**Liverpool John Lennon Airspace Change**

**ACP-2015-09**

**Stage 2 Develop and Assess**

**Step 2ai and Step 2aii- Options Development and Design Principle Evaluation Addendum**

Figure 12: The potential location for the VEGUN S1 PBN transition. The black line shows the original design and the Red swathe illustrates the updated design limits following feedback.

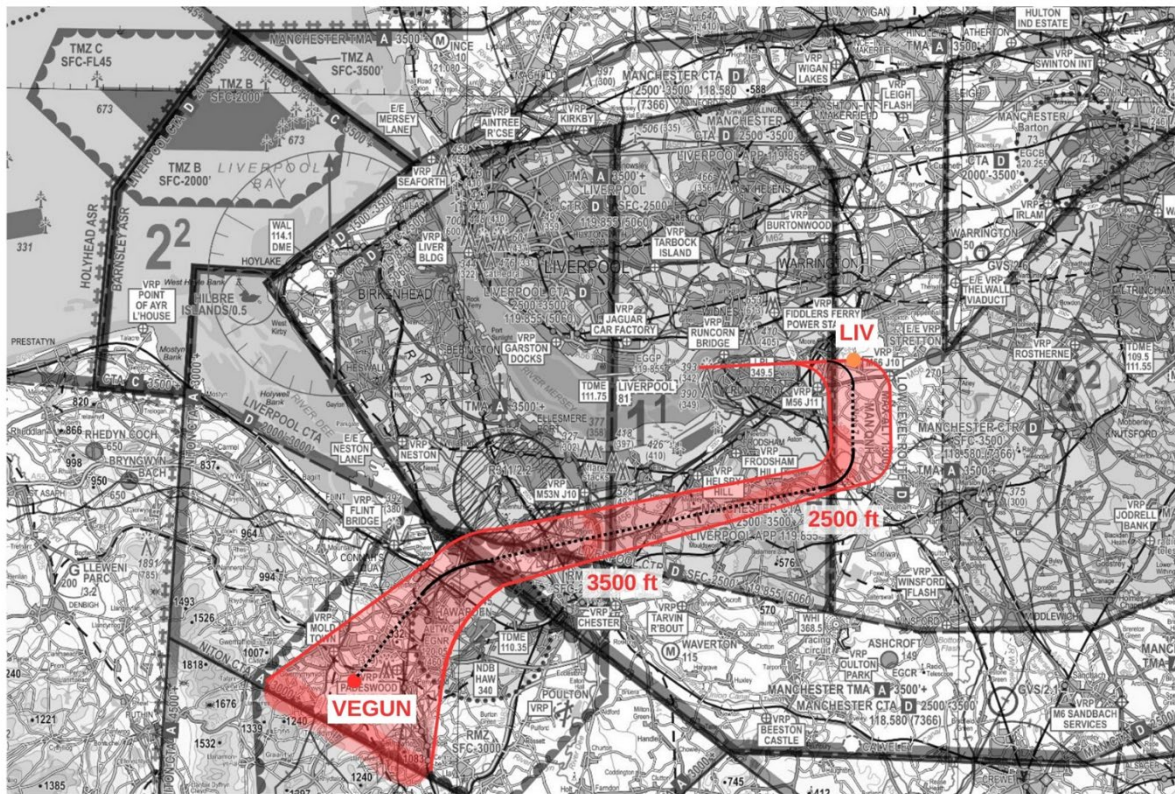
Stakeholder	Feedback	Impact
Manchester Airport	The designs for LPL arrivals to Runway 27 from the south previously advanced to Stage 4 included a base leg turn at 2,500ft requiring MAN southwest departures to reach 3,500ft at approximately 5nm before the base leg track to ensure separation. However, the climb gradient required by MAN departures to achieve this separation would be in excess of the 6% gradient that all airlines operating from MAN could achieve.	The levels presented within the presentation are indicative and subject to change during the option development work that takes place between the Stage 2 and Stage 3 gateways. However, LJLA note that current SIDs from Manchester airport runway 23 include initial climb gradients >12%. Whilst LJLA would not expect this rate to be included in the entirety of the Manchester SID design, Manchester departures are already required to have a climb performance in excess of 6% and therefore LJLA do not consider this to be a fair restriction on the design. An increased climb gradient can benefit ground-based stakeholders and should not be discounted at this stage. This and similar interactions will be considered through route separation workshops between the FASI sponsors as part of the ongoing design work required for the stage 3 submission.

Wirral Borough Council	<p>New Option Combined Vegun 1 &amp; Vegun 2 Comment: Neutral position as does not overfly the Borough.</p>	<p>The combination of VEGUN S1 and S2 is not included as an option. The slide was included to highlight the difference between the two options. Should both options progress then both could be implemented.</p>
NERL	<p>We observe that the additional transitions S1 and S2 presented are not illustrated within associated swathe(s) of option variability, neither in terms of lateral or vertical variance. Presentation is of course at the behest of the ACP sponsor however we observe this difference of presentation style between departure options(swathes) and arrival transition options(lines) could potentially suggest a</p>	<p>As discussed in the presentation the tracks presented and the levels were indicative, and both are open to refinement during the Stage 3 options refinement work. The LJLA designs for the transition options were originally presented as lines, however, within this annex they are depicted as swathes following this feedback to maximise the</p>

Norley Parish Council	Norley Parish Council were delighted to be involved in the LJLA Stage 2 Engagement process  The ACP Update Sheet was very useful as the VEGUN approaches materially affect Norley village  Should you take the LJLA ACP further, Norley Parish Council would be pleased to be involved in the consultations	LJLA wishes to thank Norley Parish Council for their feedback. Norley Parish Council will be included in all future engagement and consultation relating to this ACP.

The swathe has been widened where aircraft are expected to join the IAF to join final approach following Manchester feedback. This is to provide flexibility in the design to resolve any remaining confliction however, aircraft require a period of level flight before starting their descent and this will limit where aircraft will be able to commence this final turn.

Figure 13: The potential location for the VEGUN S1 PBN transition. The black line shows the original design and the blue swathe illustrates the updated design limits following feedback.

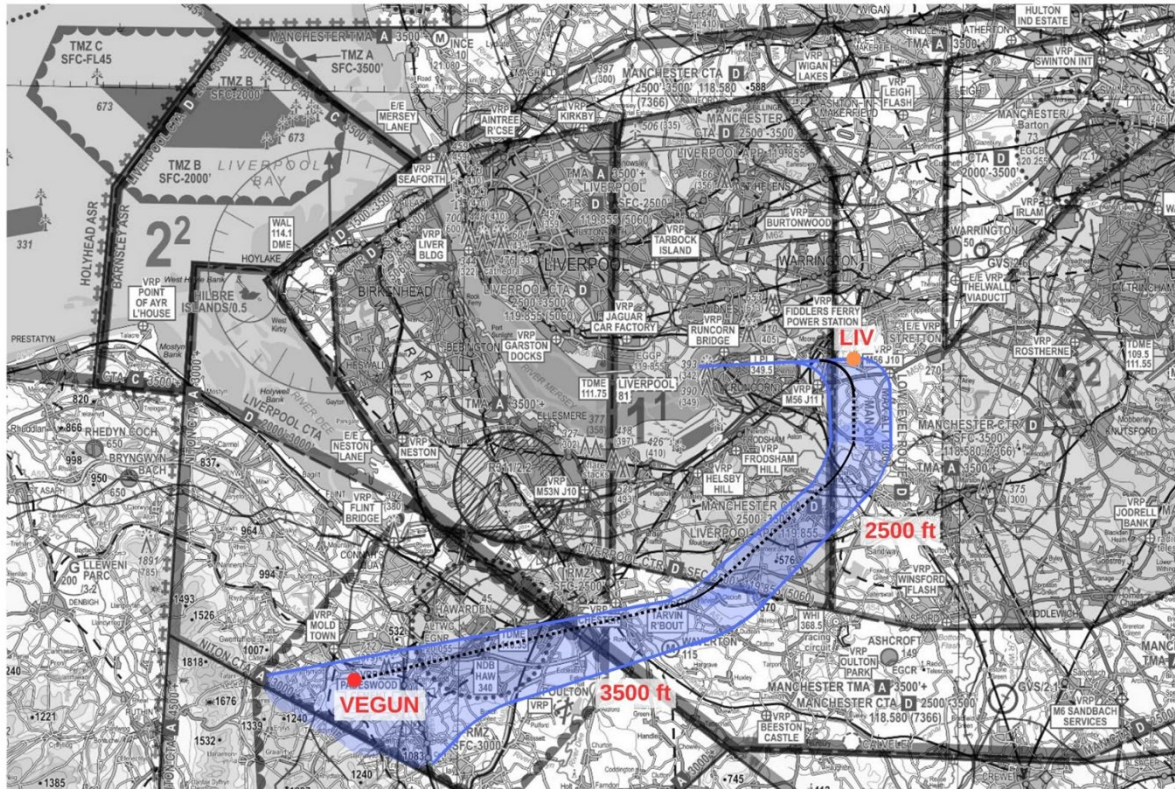
Stakeholder	Feedback	Impact
Manchester Airport	The designs for LPL arrivals to Runway 27 from the south previously advanced to Stage 4 included a base leg turn at 2,500ft requiring MAN southwest departures to reach 3,500ft at approximately 5nm before the base leg track to ensure separation. However, the climb gradient required by MAN departures to achieve this separation would be in excess of the 6% gradient that all airlines operating from MAN could achieve.	The levels presented within the presentation are indicative and subject to change during the option development work that takes place between the Stage 2 and Stage 3 gateways. However, LJLA note that current SIDs from Manchester airport runway 23 include initial climb gradients >12%. Whilst LJLA would not expect this rate to be included in the entirety of the Manchester SID design, Manchester departures are already required to have a climb performance in excess of 6% and therefore LJLA do not consider this to be a fair restriction on the design. An increased climb gradient can benefit ground-based stakeholders and should not be discounted at this stage.

Wirral Borough Council	New Option Combined Vegun 1 & Vegun 2 Comment: Neutral position as does not overfly the Borough.	The combination of VEGUN S1 and S2 is not included as an option. The slide was included to highlight the difference between the two options. Should both options progress then both could be implemented.
NERL	We observe that the additional transitions S1 and S2 presented are not illustrated within associated swathe(s) of option variability, neither in terms of lateral or vertical variance. Presentation is of course at the behest of the ACP sponsor however we observe this difference of presentation style between departure options(swathes) and arrival transition options(lines) could potentially suggest a degree of options appraisal finality in terms of transitions S1 & S2 in route and vertical profile.	<p>As discussed in the presentation the tracks presented and the levels were indicative and both are open to refinement during the Stage 3 options refinement work. The LJLA designs for the transition options were originally presented as lines, however, within this annex they are depicted as swathes following this feedback to maximise the flexibility within the designs to minimise the cumulative impact.</p> <p>However, the conceptual nature of the design options means that specific design decisions as a result of this feedback cannot be made until more detailed options are developed in Stage 3.</p>

Norley Parish Council	Norley Parish Council were delighted to be involved in the LJLA Stage 2 Engagement process  The ACP Update Sheet was very useful as the VEGUN approaches materially affect Norley village  Should you take the LJLA ACP further, Norley Parish Council would be pleased to be involved in the consultations	LJLA wishes to thank Norley Parish Council for their feedback. Norley Parish Council will be included in all future engagement and consultation relating to this ACP.

The swathe has been widened where aircraft are expected to join the IAF to join final approach following Manchester feedback. This is to provide flexibility in the design to resolve any remaining confliction, however aircraft require a period of level flight before starting their descent and this will limit where aircraft will be able to commence this final turn.

Figure 14: The potential location for a SID departing runway 09 with a right turn to join the ATS network in the North East.

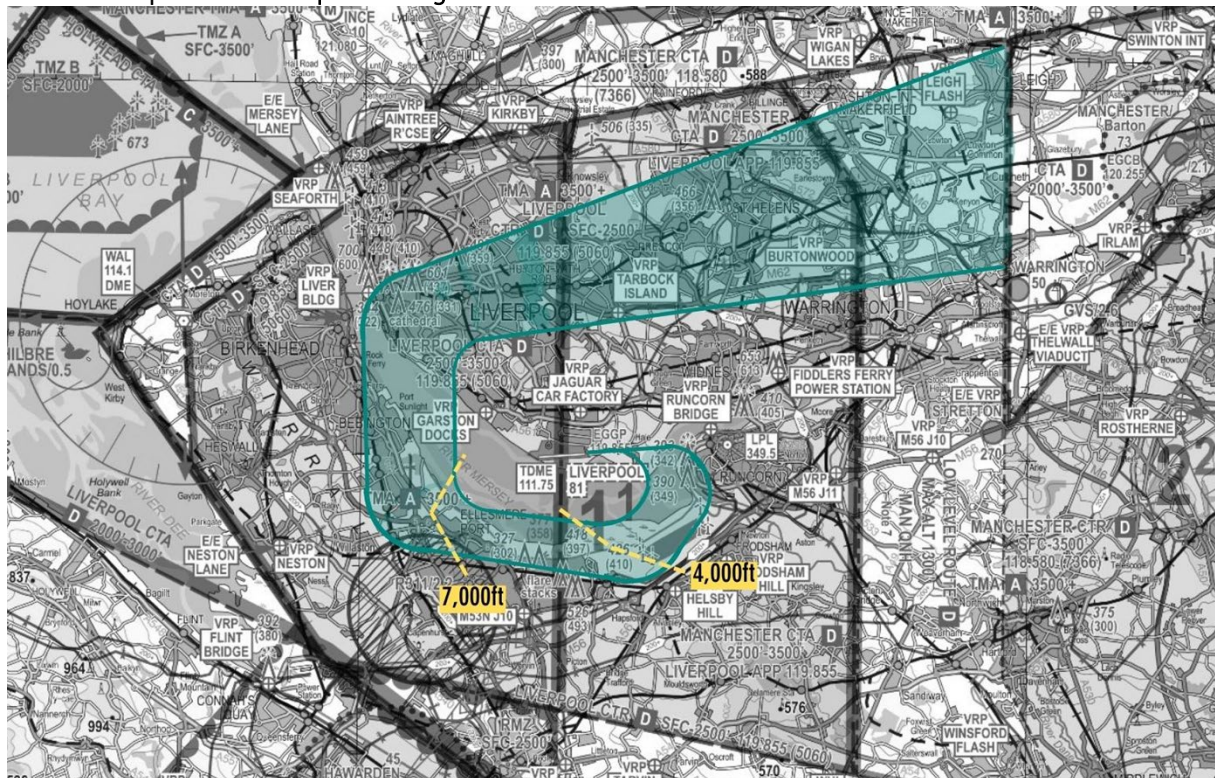
Wirral Resident	I object to each of the departure options, apart from depart right to NW and depart left to W, both of which I strongly object to.	We note your objection, however no design decisions can be made from this feedback.
British Gliding Association	As they are wholly contained within existing Controlled Airspace, they have no impact on current gliding operations	LJLA wishes to thank the BGA for their feedback. No update required to Design.
Liverpool City Council	With regards to some of the 09 Departure options, the turn to the right seems to take planes over the Mersey estuary more, compared with the equivalent left turns which take planes over densely populated areas of south Liverpool.	<p>LJLA agrees with this assessment, and it will be reflected in the DPE.</p> <p>However, the conceptual nature of the design options means that specific design decisions as a result of this feedback cannot be made until more detailed options are developed in Stage 3.</p>

Figure 15: The potential location for a SID departing runway 09 with a left turn to join the ATS network in the Northeast.

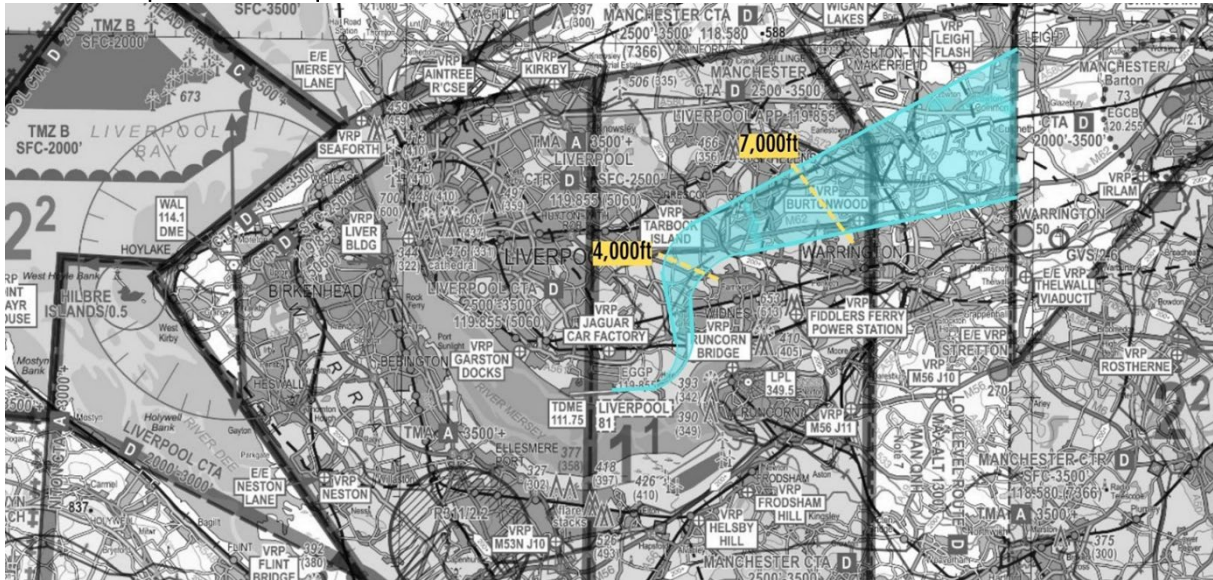
Wirral Resident	I am neutral about depart left to NE, depart right to S.	We note your neutral position, however no design decisions can be made from this feedback.
British Gliding Association	As they are wholly contained within existing Controlled Airspace, they have no impact on current gliding operations	LJLA wishes to thank the BGA for their feedback. No update required to Design.
Liverpool City Council	With regards to some of the 09 Departure options, the turn to the right seems to take planes over the Mersey estuary more, compared with the equivalent left turns which take planes over densely populated areas of south Liverpool.	<p>LJLA agrees with this assessment, and it will be reflected in the DPE.</p> <p>However, the conceptual nature of the design options means that specific design decisions as a result of this feedback cannot be made until more detailed options are developed in Stage 3.</p>

Flintshire County Council	Departure options have minimal impact within the Airspace above Flintshire County Council	LJLA wishes to thank the Flintshire County Council for their feedback. No update required to Design.
NERL	NATS NERL (MTMA) has no 'local factors' knowledge that may or may not apply or influence LJL options to 7000ft and is unable to comment on such aspects however, the additional departure swathes presented in this engagement indicatively suggest NERL network compatibility both within the requirements of a Stage 2 ACP and in terms of option(s) flexibility that remains to be fully determined within the indicative swathes utilising Route Separation and Cumulative Assessment Framework technical collaborative assessment with relevant ACP stakeholders.	LJLA wishes to thank the NERL for their feedback. No update required to Design at this stage.
Wirral Resident	Neutral	We note your neutral position, however no design decisions can be made from this feedback.

Figure 16: The potential location for a SID departing runway 09 with a right turn to join the ATS network in the South.

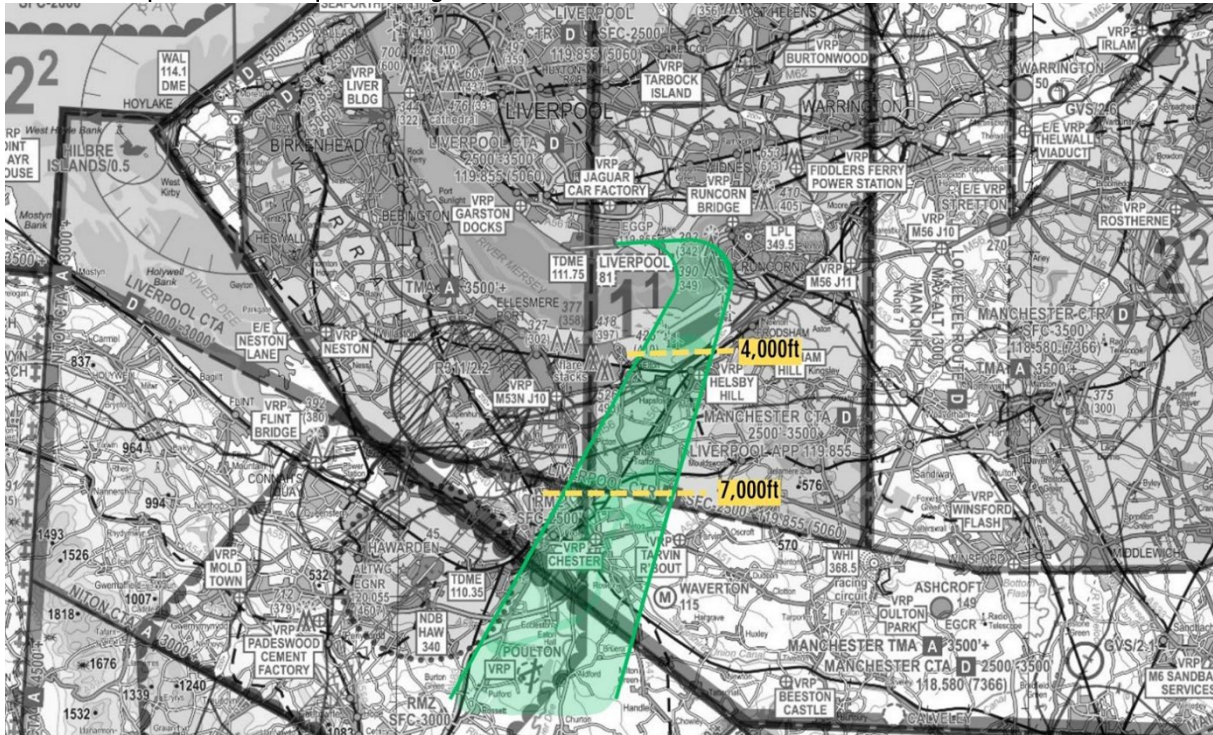
Wirral Resident	I am neutral about depart left to NE, depart right to S.	We note your neutral position, however no design decisions can be made from this feedback.
British Gliding Association	As they are wholly contained within existing Controlled Airspace, they have no impact on current gliding operations	LJLA wishes to thank the BGA for their feedback. No update required to Design.
Liverpool City Council	With regards to some of the 09 Departure options, the turn to the right seems to take planes over the Mersey estuary more, compared with the equivalent left turns which take planes over densely populated areas of south Liverpool.	<p>LJLA agrees with this assessment, and it will be reflected in the DPE.</p> <p>However, the conceptual nature of the design options means that specific design decisions as a result of this feedback cannot be made until more detailed options are developed in Stage 3.</p>

Flintshire County Council	Departure options have minimal impact within the Airspace above Flintshire County Council	LJLA wishes to thank the Flintshire County Council for their feedback. No update required to Design.
NERL	NATS NERL (MTMA) has no 'local factors' knowledge that may or may not apply or influence LJA options to 7000ft and is unable to comment on such aspects however, the additional departure swathes presented in this engagement indicatively suggest NERL network compatibility both within the requirements of a Stage 2 ACP and in terms of option(s) flexibility that remains to be fully determined within the indicative swathes utilising Route Separation and Cumulative Assessment	LJLA wishes to thank the NERL for their feedback. No update required to Design at this stage.

Figure 17: The potential location for a SID departing runway 09 with a left turn to join the ATS network in the South.

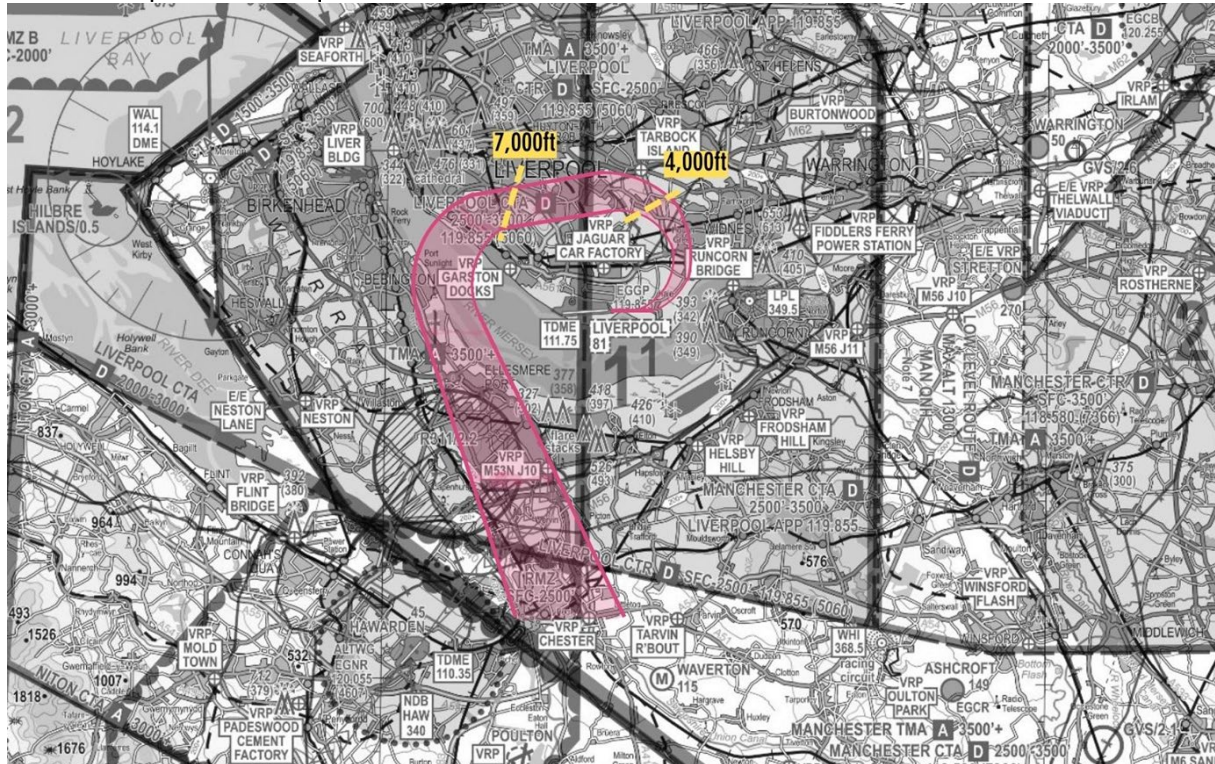
British Gliding Association	As they are wholly contained within existing Controlled Airspace, they have no impact on current gliding operations	LJLA wishes to thank the BGA for their feedback. No update required to Design.
Liverpool City Council	With regards to some of the 09 Departure options, the turn to the right seems to take planes over the Mersey estuary more, compared with the equivalent left turns which take planes over densely populated areas of south Liverpool.	<p>LJLA agrees with this assessment, and it will be reflected in the DPE.</p> <p>However, the conceptual nature of the design options means that specific design decisions as a result of this feedback cannot be made until more detailed options are developed in Stage 3.</p>
Ryanair	Right turns from 09 for NE departures & left turns from 09 to the SE are environmentally and economically inefficient as they significantly increase track miles flown and therefore, fuel burn, emissions and flight time which affect commercial schedules, costs and company 'green' targets.	<p>LJLA acknowledges with this assessment, and it will be reflected in the DPE.</p> <p>However, the conceptual nature of the design options means that specific design decisions as a result of this feedback cannot be made until more detailed options are developed in Stage 3.</p>

Stakeholder	Feedback	Impact
NERL	NATS NERL (MTMA) has no 'local factors' knowledge that may or may not apply or influence LJL options to 7000ft and is unable to comment on such aspects however, the additional departure swathes presented in this engagement indicatively suggest NERL network compatibility both within the requirements of a Stage 2 ACP and in terms of option(s) flexibility that remains to be fully determined within the indicative swathes utilising Route Separation and Cumulative Assessment Framework technical collaborative assessment with relevant ACP stakeholders.	LJLA wishes to thank the NERL for their feedback. No update required to Design at this stage.
Wirral Resident	Object	LJLA notes your objection, however no design decisions can be made from this feedback.
Wirral Borough Council	Object as overflies densely populated area in East Wirral. This option appears to use more power to enable the aircraft to climb to over 7000ft but will affect areas being developed for housing as part of our Local Plan under consideration. Design principle 3 specifically refers to the need to avoid overflight of 'country park's ' and 'high risk industrial sites'.	LJLA notes your objection and population overflight will be considered within the DPE. These designs seek to minimise the impact of overflight by enabling improved CCO and increasing the SID end levels. This will be refined during the Stage 3 development work. The options as presented are in swathes which will enable LJLA to develop a solution which is compatible with the other FASI sponsors whilst benefiting local residents. The Design principles do not prohibit the overflight of high risk industrial sites but insures LJLA assess this overflight and endeavours to avoid it where able.  However, the conceptual nature of the design options means that specific design decisions as a result of this feedback cannot be made until more detailed options are developed in Stage 3.

Figure 18: The potential location for a SID departing runway 09 with a right turn to join the ATS network in the Northwest.

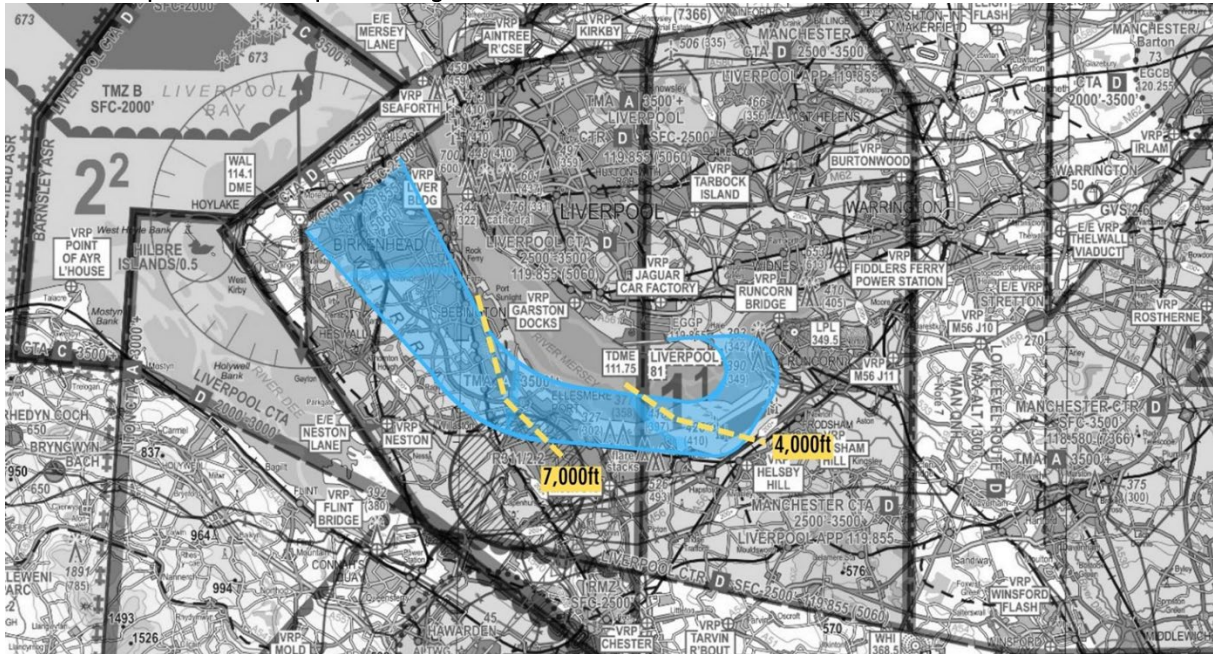
British Gliding Association	As they are wholly contained within existing Controlled Airspace, they have no impact on current gliding operations	LJLA wishes to thank the BGA for their feedback. No update required to Design.
Liverpool City Council	With regards to some of the 09 Departure options, the turn to the right seems to take planes over the Mersey estuary more, compared with the equivalent left turns which take planes over densely populated areas of south Liverpool.	<p>LJLA agrees with this assessment, and it will be reflected in the DPE.</p> <p>However, the conceptual nature of the design options means that specific design decisions as a result of this feedback cannot be made until more detailed options are developed in Stage 3.</p>
Ryanair	Right turns from 09 to NW are fine.	<p>LJLA acknowledges this assessment, and it will be reflected in the DPE.</p> <p>However, the conceptual nature of the design options means that specific design decisions as a result of this feedback cannot be made until more detailed options are developed in Stage 3.</p>
